Office of Superintending Engineer World Bank Project Circle P.W.D., Kanpur

Letter No.:- 800 / 5C-WBPCK / 2023

Sub: Construction of 2-lane missing link road from Rath Bypass (Hamirpur District) to Garautha (Jhansi District) of SH-42 in the State of Uttar Pradesh — (Online Forest Proposal No-FP/UP/ROAD/117342/2020) Regarding Regional Empowered Committee's (REC) EDS Compliance Status Report

Ref.: REC (MoEFCC), IRO Lucknow MOM No. 11/1092/REC/2014/U.P./2191 Dated 27.02.2023 - DFO, Jhansi to UPPWD ref. no....

Digital Georeferenced GIS Map of Proposed CA Land in the Range of Kuchecha, District Hamirpur Under Proposed UPCRNDP-SH42 Missing Link

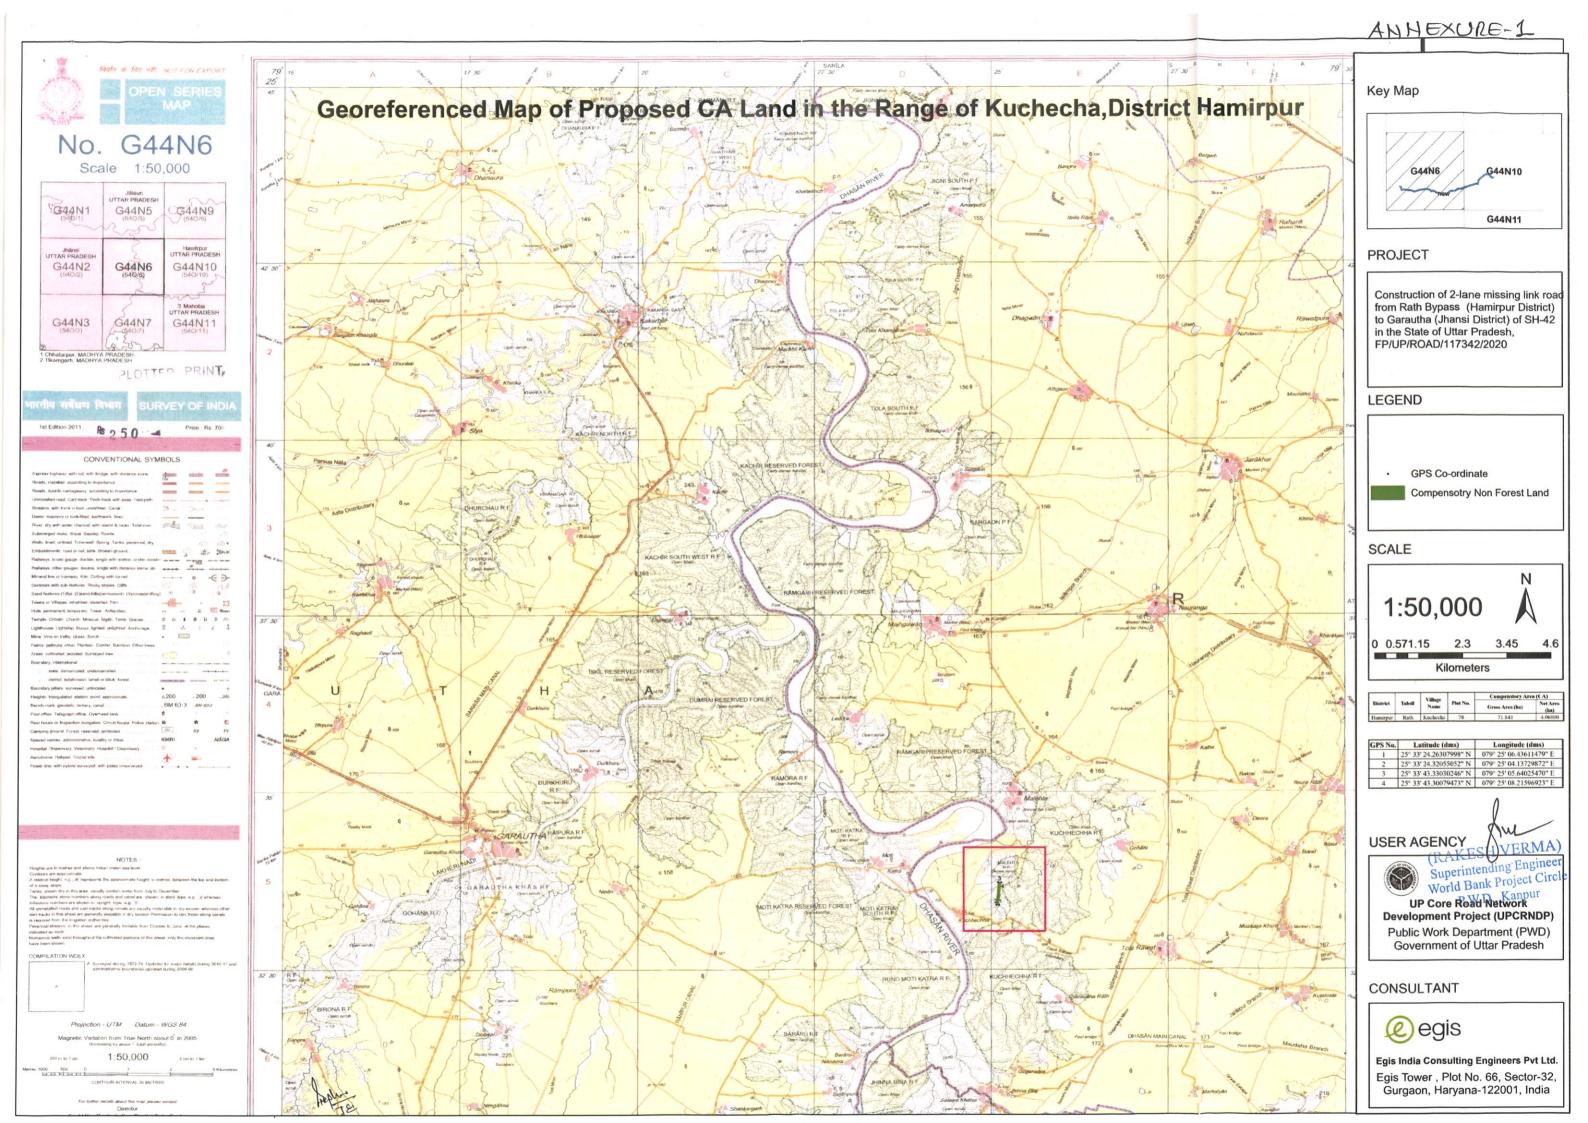
2.	As per the DSS and SOI toposheet, the proposed NFL CA land polygon falls under the Kuchhechha R.F and Durkhuru R.F area. This needs rectification/ clarification.	Proposed CA land of village Raipura has been re- examined by Jhansi Forest Department in coordination with UPPWD on 01.03.2023. After detailed examination Forest Range office reconfirmed that the proposed CA land is correctly demarcated and does not falling under Durkhuru R.F. The signed copy of the Re-verification/ examination report is enclosed herewith as Annexure- 2.2. There is no requirement of any fresh/new Non- Forest CA Land.

TITLE TYPICAL CROSS SECTIONS EGIS/DPR/EIRH1UP020/DPR/TCS- 001

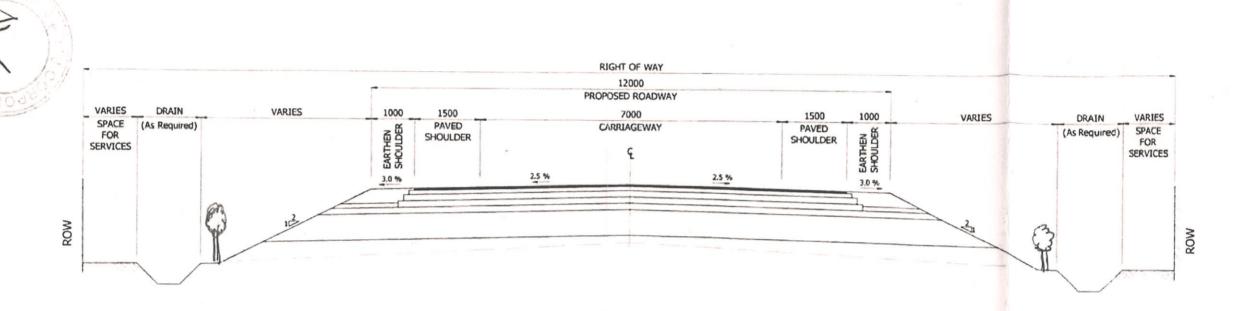
7.	Details of existing ROW, Proposed ROW and land width (ROW) availability for road side plantation needs to be submitted and accordingly plantation scheme for roadside	The widening varies throughout the alignment proposed under project. The list of the Existing ROW, Proposed ROW is enclosed herewith as Annexure-3 for reference. The Tree Plantation shall be carried out based on the
	plantation needs to be submitted.	availability of space within ROW. A detailed roadside
		plantation scheme on Typical Cross Sections is enclosed
		herewith as Annexure-5.
